Lynn Lake Gold Project: MacLellan Mine Plan Amendment Notice of Alteration / Notice of Change

Federal Information Request Responses – Round 2

September 19, 2025

Response to IAAC NOC IR-14-2

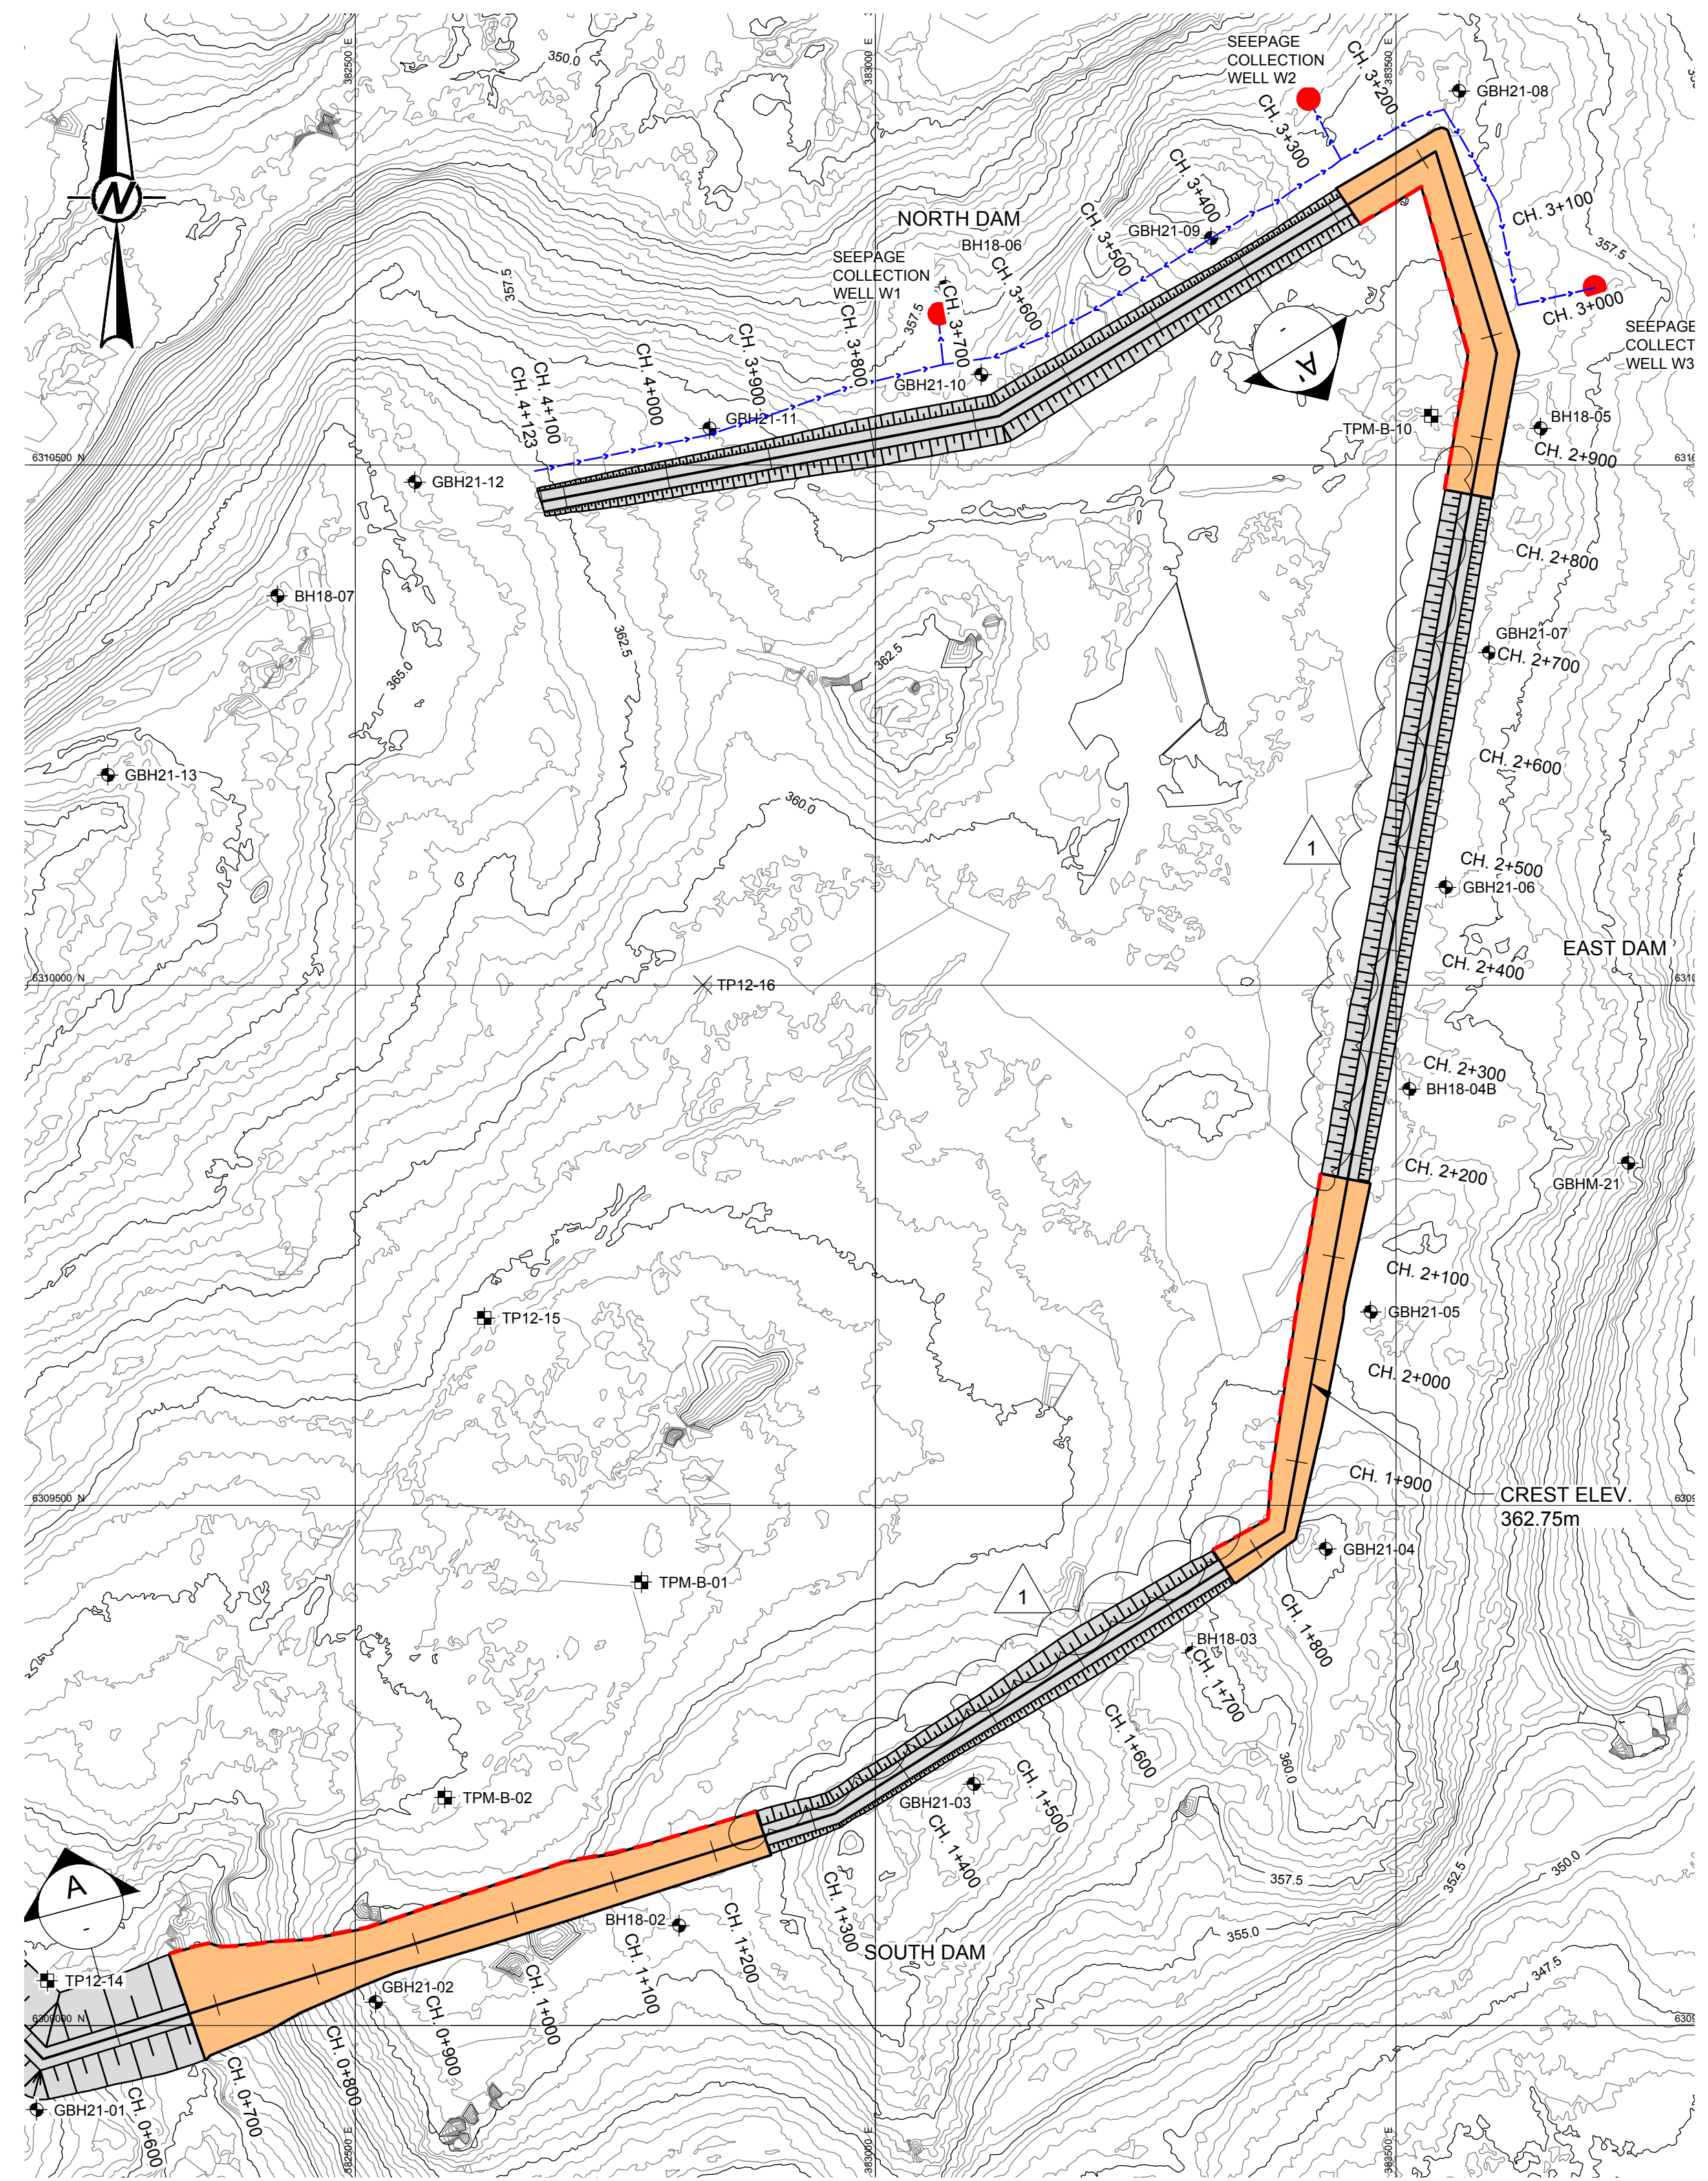
ID:	NOC IR-14-2
Topic	Water quality Mitigation Measures, Fish and Fish Habitat
Expert Department or Group:	ECCC IAAC
NOA/NOC reference:	Section 4.0 – Conclusions Appendix G – Surface Water Quality Figures Surface Water Management and Monitoring Plan (Version 0 – January 2025)
Information Request:	<p>IAAC Follow-Up Questions:</p> <p>a) Please describe which of the mitigation measures in Table E-1 were included in the modelling presented in the NOC that mitigate surface water impacts to the three water bodies where changes in magnitude are predicted in Table 3.24.</p> <p>b) Please explain why the specific additional adaptive management strategies you reference in section 3.3.5.3 (which references the measures on pg. 89-90 of the Jan 30th version of Surface Water Management Plan) can be relied on to effectively reduce residual water quality effects in Table 3.24 of the NOC to those predicted in Table 9-36 of the EIS.</p> <p>c) Which of these measures mentioned above (or any others) could be implemented proactively instead of relying on adaptive management. If none can be implemented proactively, please explain why.</p>

Response:	<p>a) Mitigation measures presented in Table E-1 that were included in the modelling presented in the NOC that mitigate surface water impacts were seepage collection ditches around the TMF and MRSA, however they were modelled to a uniform depth of 1 m and not modelled to the expected differing depths that are included in the engineering detailed design. No other mitigation measures were included in the modelling presented in the NOC. The results presented do not take into account any planned or adaptive mitigation measures, nor any flow-path attenuation or chemical changes that are expected to occur (reactive transport) as groundwater flows towards the three water bodies. The models also do not take into account the compaction of the underlying overburden (containing clay) with the weight of the tailings. On this basis, the seepage predictions and resulting predicted changes in magnitude are highly conservative.</p> <p>b) Mitigation measures including increasing the depth of seepage collection ditches and/or the installation of pump-back wells would both increase the capture of TMF and/or MRSA seepage that would otherwise report to surrounding lakes and</p>

ID:	NOC IR-14-2
	<p>streams. This reduction of seepage migration into the water bodies would reduce residual water quality effects.</p> <p>c) Discussions with engineers involved in the detailed design of the TMF and MRSA, have identified that there will be three seepage collection wells with a subsurface drain around the TMF as well as grout curtains installed from the top of bedrock to a depth of between 10 and 15 m through the upper fractured bedrock. Drawings are attached to this response. These five features – which were not modelled within the 3D groundwater model – were simulated with a 2D seepage model and show that the grout curtain addition halves the seepage towards the water bodies (in comparison to model results without the grout curtain in place).</p> <p>With the committed additions to the TMF and MRSA design, the implementation of the Management and Monitoring Plans (for early detection of potential issues requiring additional mitigation) and the ability for grout curtains to be deepened, pump-back wells to be installed, and/or other mitigative measures, the water quality effects to Payne Lake, Minton Lake, and Tributary KEE3-B are not predicted to be altered from the approved project effects.</p> <p>It is important to note that Alamos acquired MonitorPro Web by EHS Data (MonitorPro) as an environmental data management software designed to streamline regulatory compliance and environmental monitoring. MonitorPro is one of our mitigation tools, enabling proactive environmental data management by allowing us to react quickly based on real-time monitoring results and imported environmental sample data such as water, air, vibration, noise, and wildlife. As soon as laboratory or field data is submitted, the system imports the results, calculates and compares them against applicable regulatory limits, internal thresholds, and/or modelled predictions, issuing automated alerts and warning notifications when results approach or exceed set criteria. This real-time comparison allows potential exceedances or trends toward non-compliance to be immediately identified, giving us the ability to implement timely mitigation measures, amend or enhance existing practices, and apply adaptive management strategies before non-compliance occurs.</p> <p>With its web-based interface, MonitorPro provides accessible, accurate, and actionable data insights that builds a robust basis for continuous improvement in environmental performance.</p> <p>In addition, the Adaptive Management Framework within the Management & Monitoring Plans was developed with staged triggers to accommodate varying levels of concern and a diversity of actions. This allows timely and informative responses to be initiated before high impact thresholds are triggered. We have used groundwater quality trend analysis as the first trigger for groundwater, which is an early warning tool to determine potential for triggering subsequent thresholds. This means that a change in trend would trigger a review of data even if it is a meteorological effect, which allows early detection of changing conditions.</p>

ID:	NOC IR-14-2
	During operation, the mean travel time is 13 years. During closure, this increases to 60 years. This means that there will be time to detect, intervene, and mitigate (as required) any potential water quality issues beyond that predicted in the EIS.
Attachment	Yes – see Appendix A
